RS-13-266  
December 20, 2013

LaSalle County Station, Unit 1  
Facility Operating License No. NPF-11  
NRC Docket No. 50-373

Subject: License Amendment Request to Revise Reactor Coolant System (RCS)  
Pressure and Temperature (P/T) Curves for LaSalle County Station, Unit 1

Figure 3.4.11-1 (Page 1 of 1)

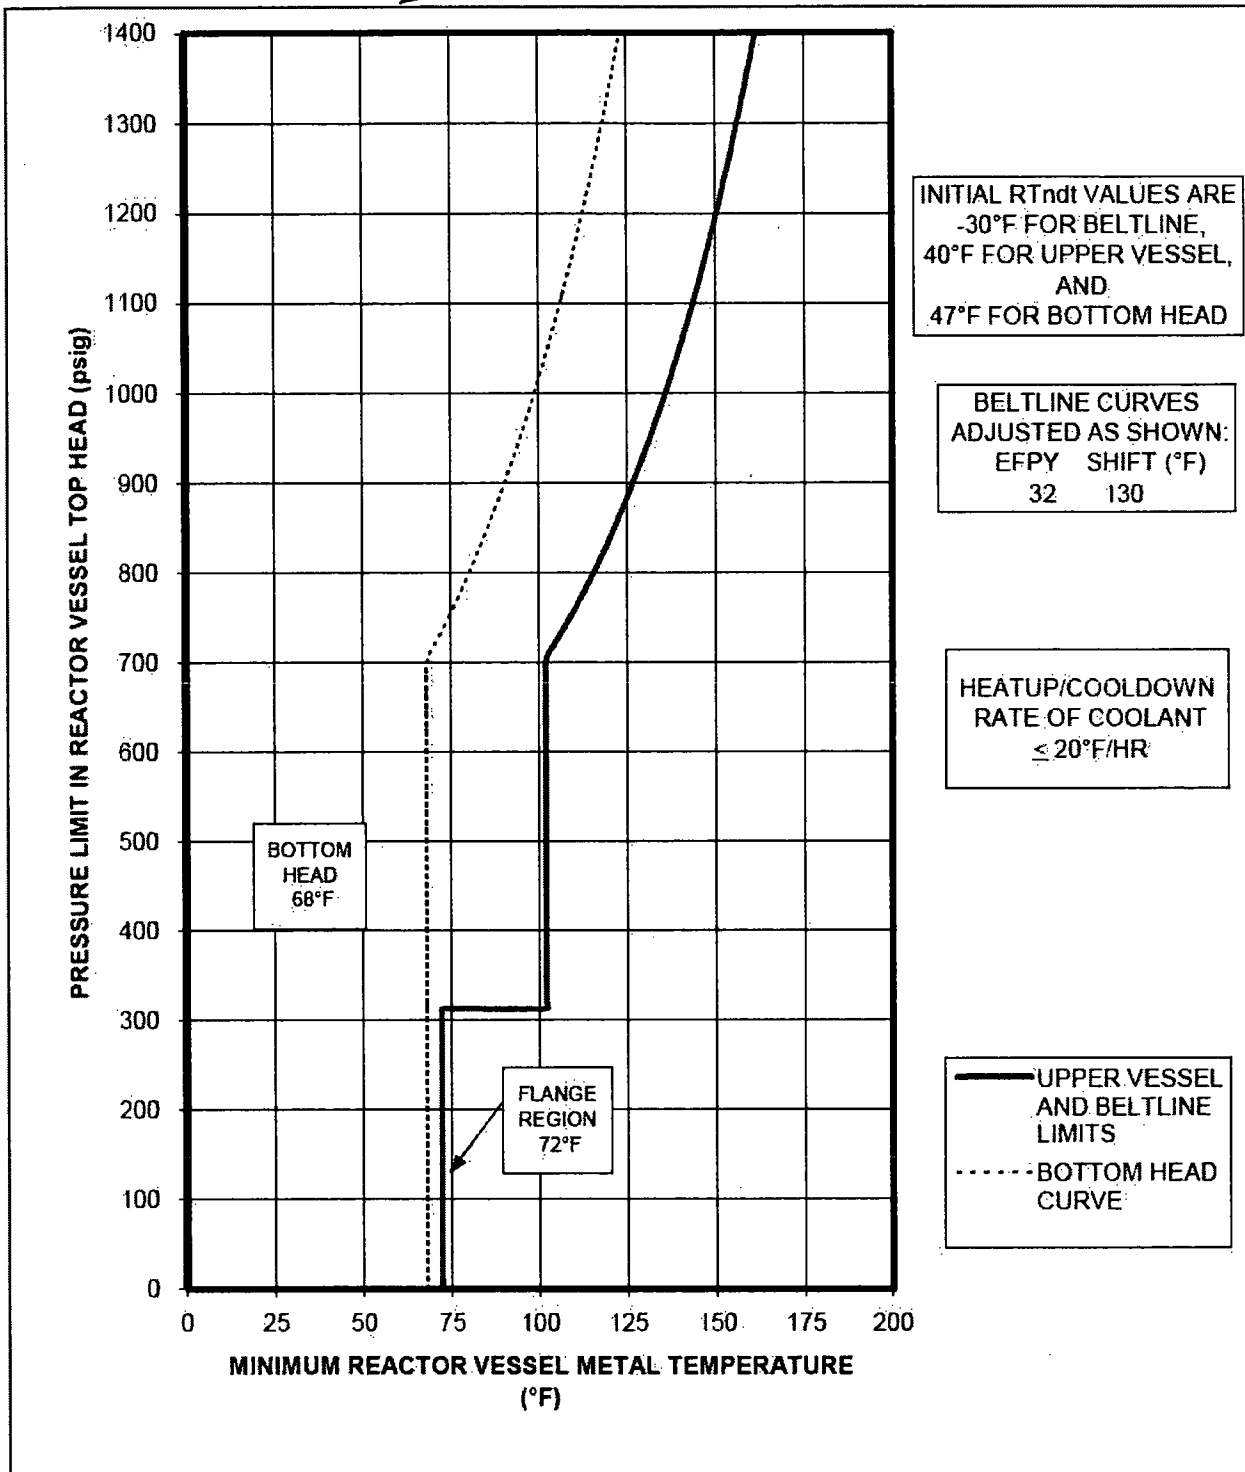
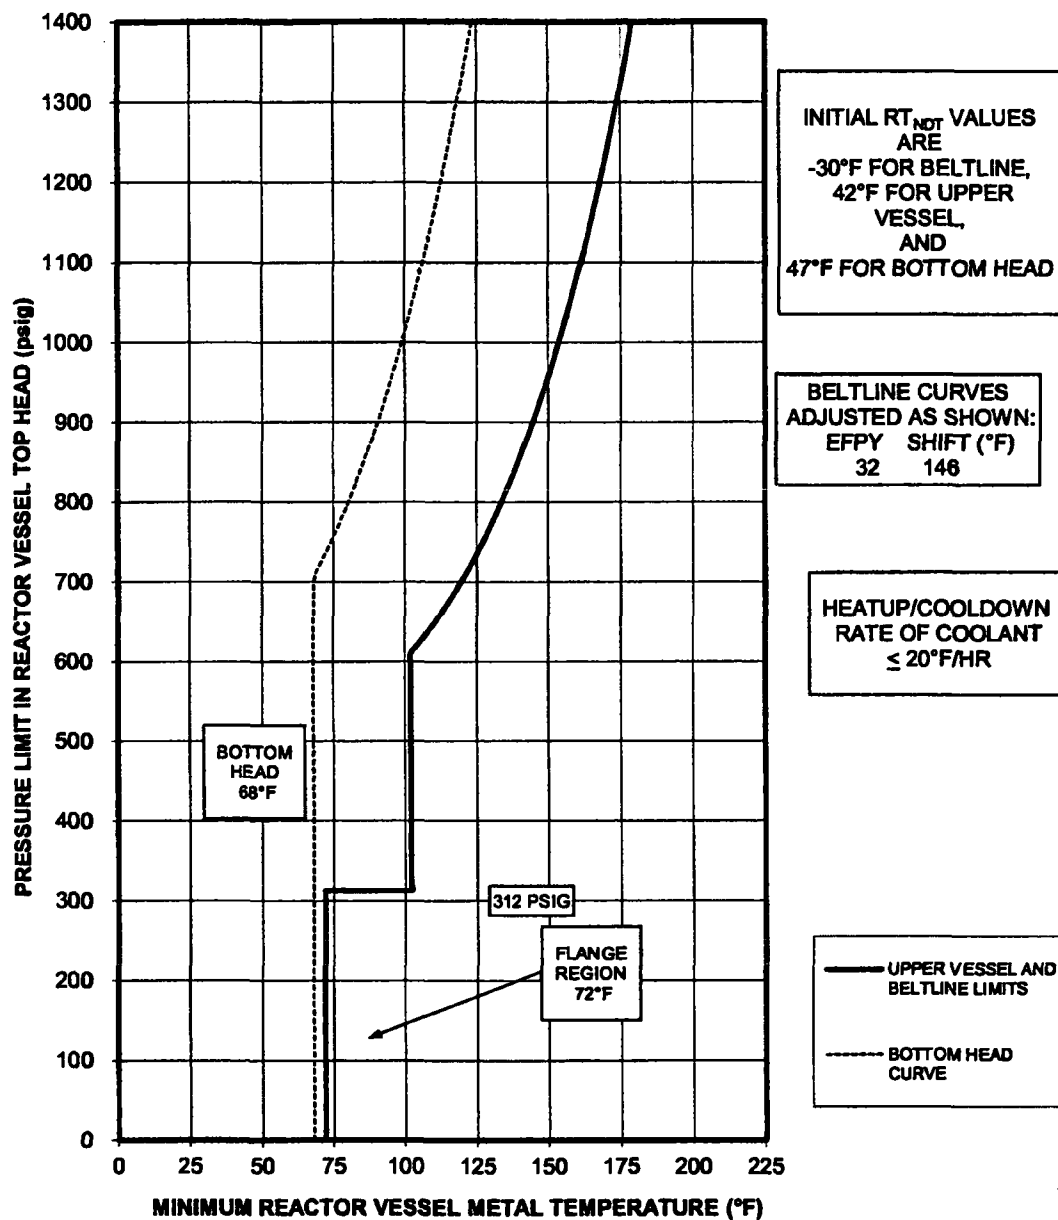
DELETE and  
INSERT new  
Figure 3.4.11-1

**New Figure 3.4.11-1**

Figure 3.4.11-2 (Page 1 of 1)  
Unit 1

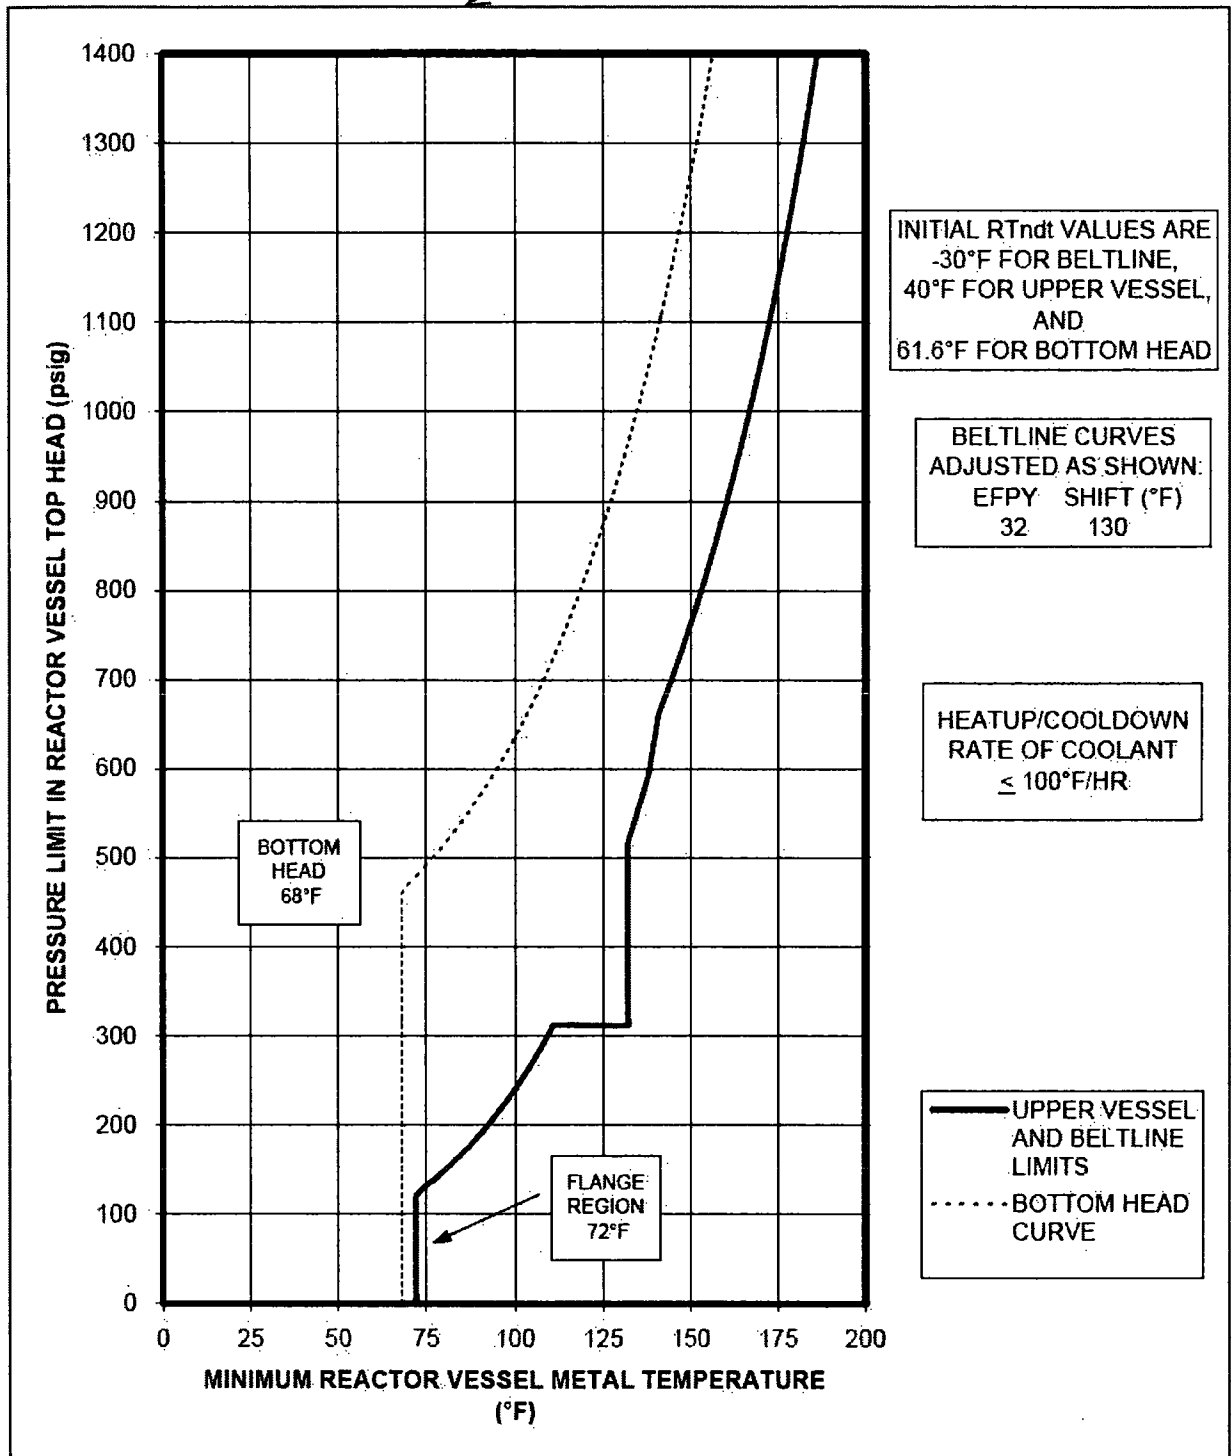
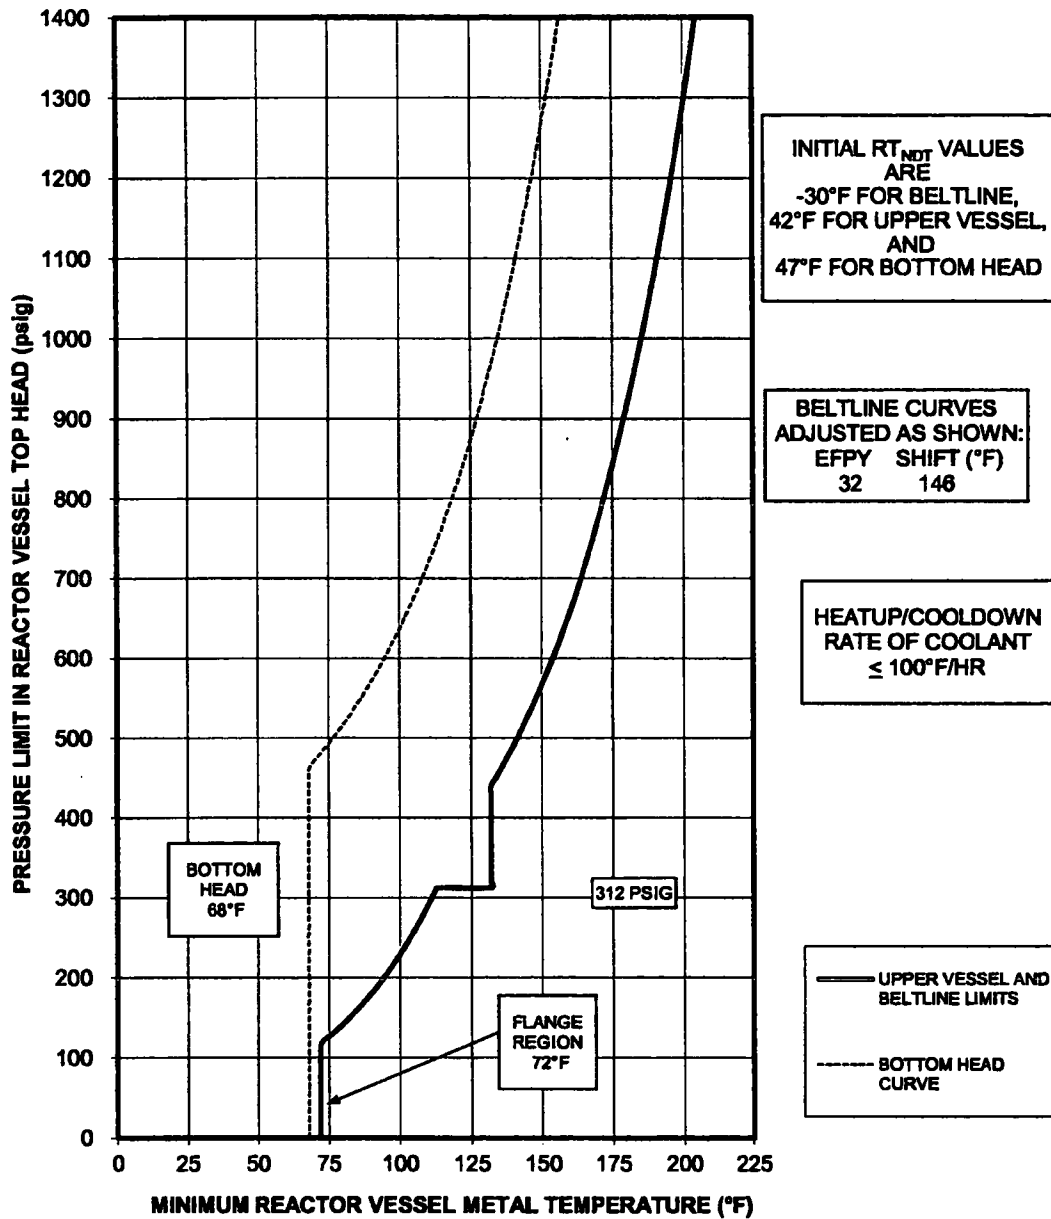
DELETE and  
INSERT new  
Figure 3.4.11-2

**New Figure 3.4.11-2**

Figure 3.4.11-3 (Page 1 of 1)  
Unit 1  
P-T Curves for Operation with a Core Critical  
other than Low Power Physics Testing up to 32 EFY

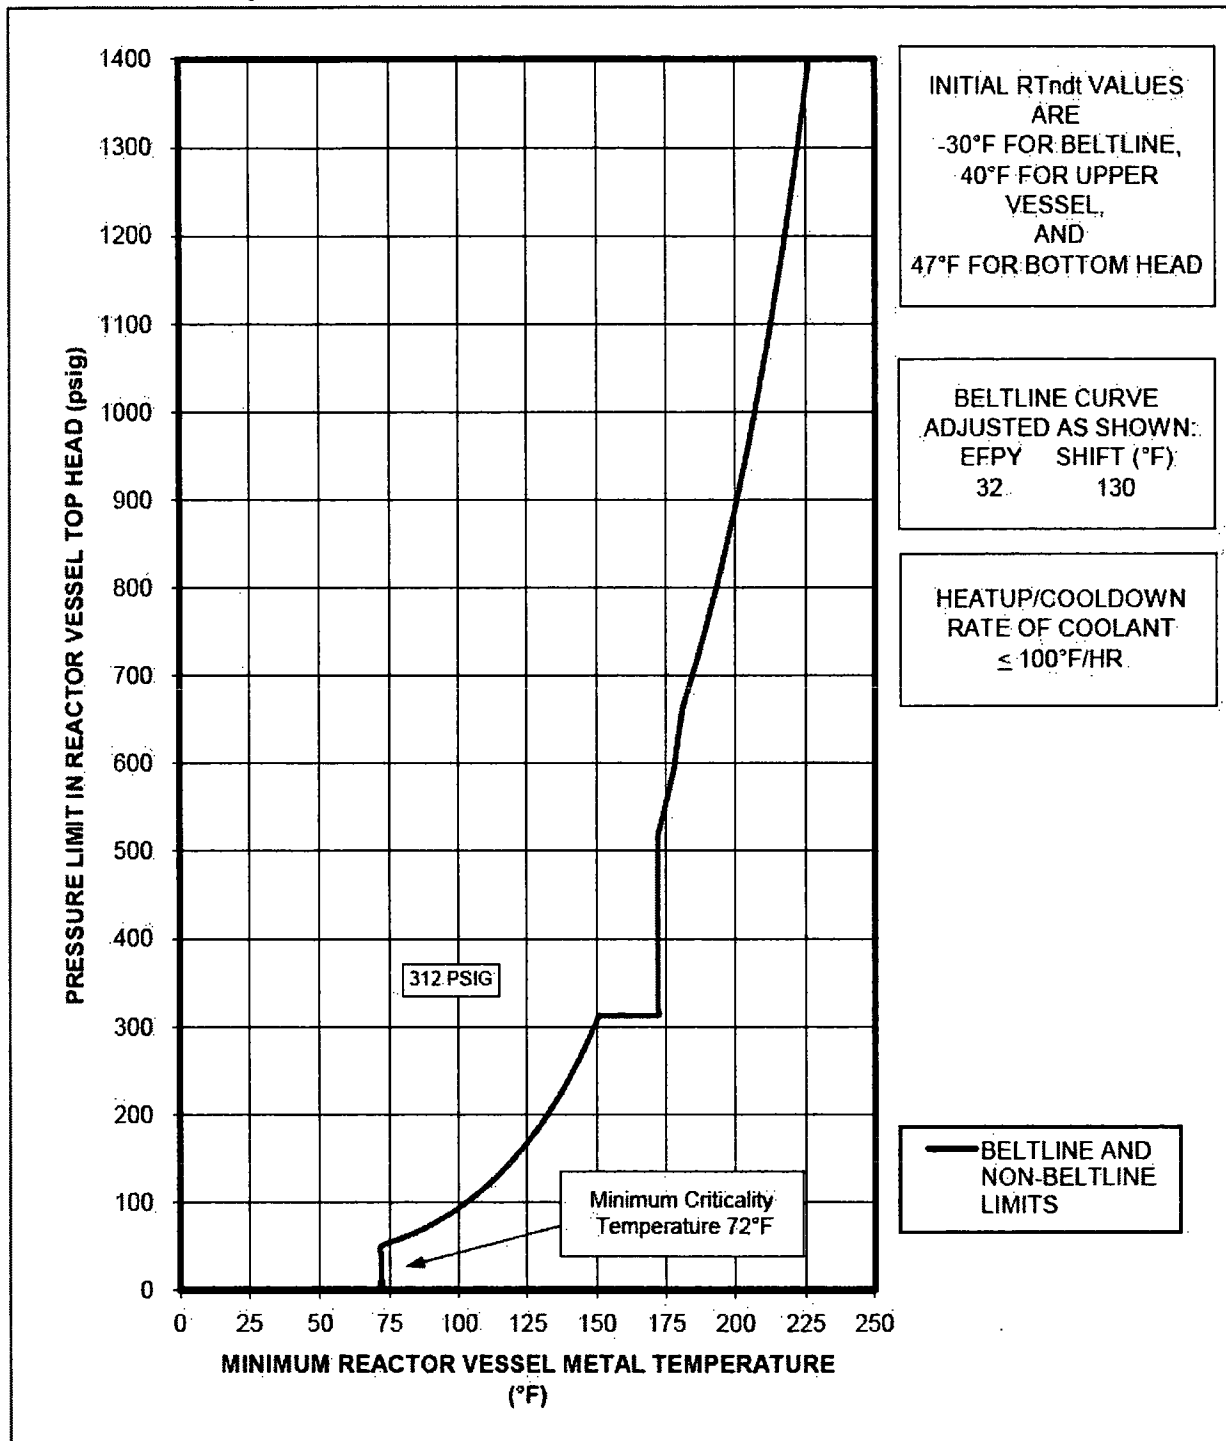
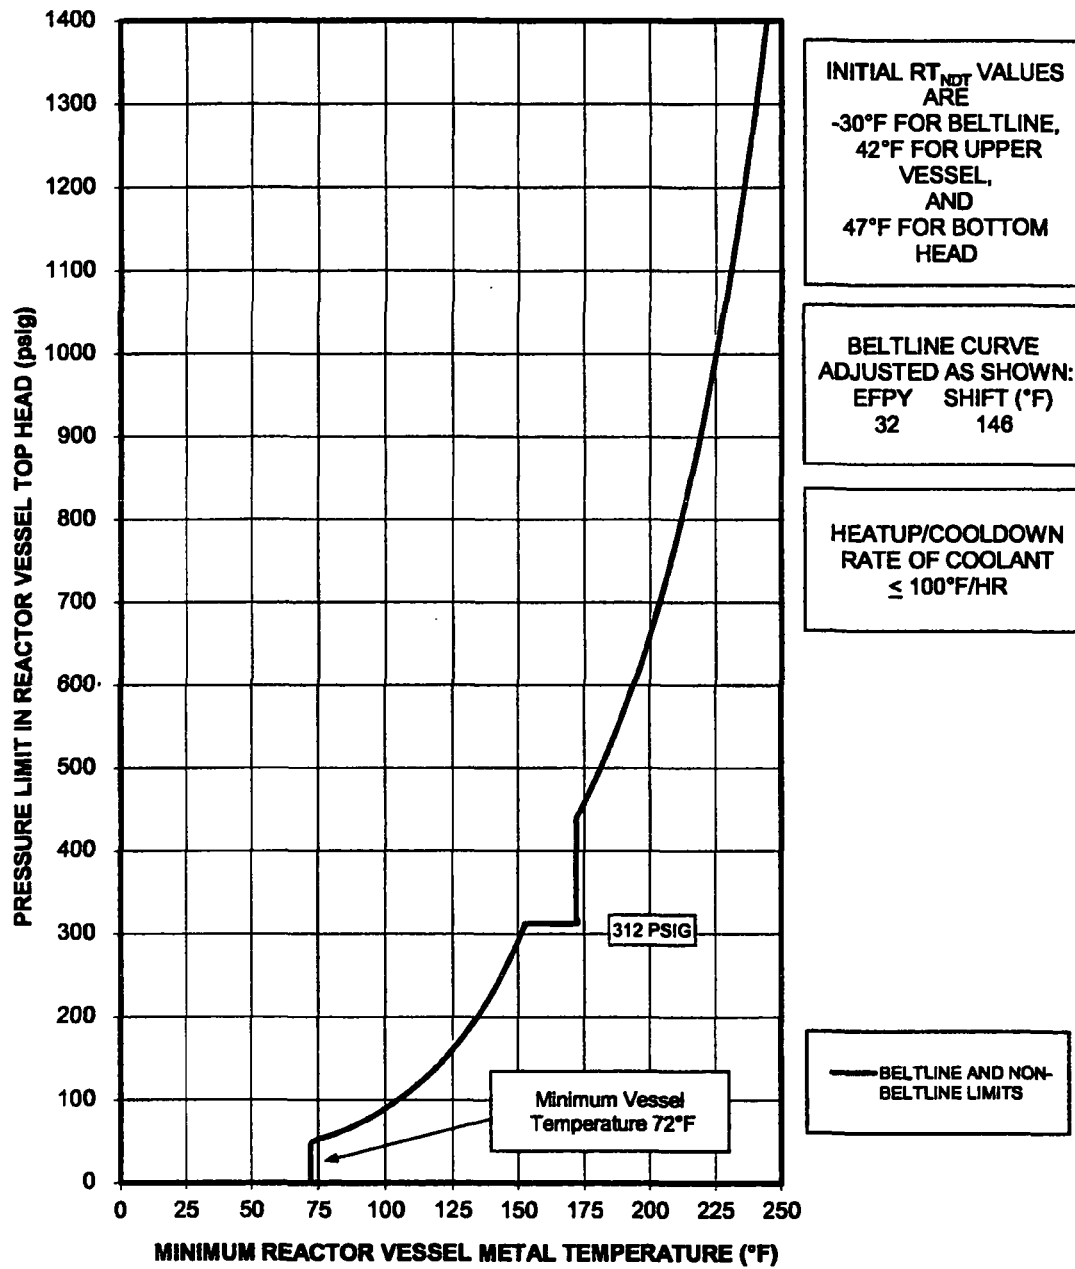
DELETE and INSERT  
new Figure 3.4.11-3

New Figure 3.4.11-3
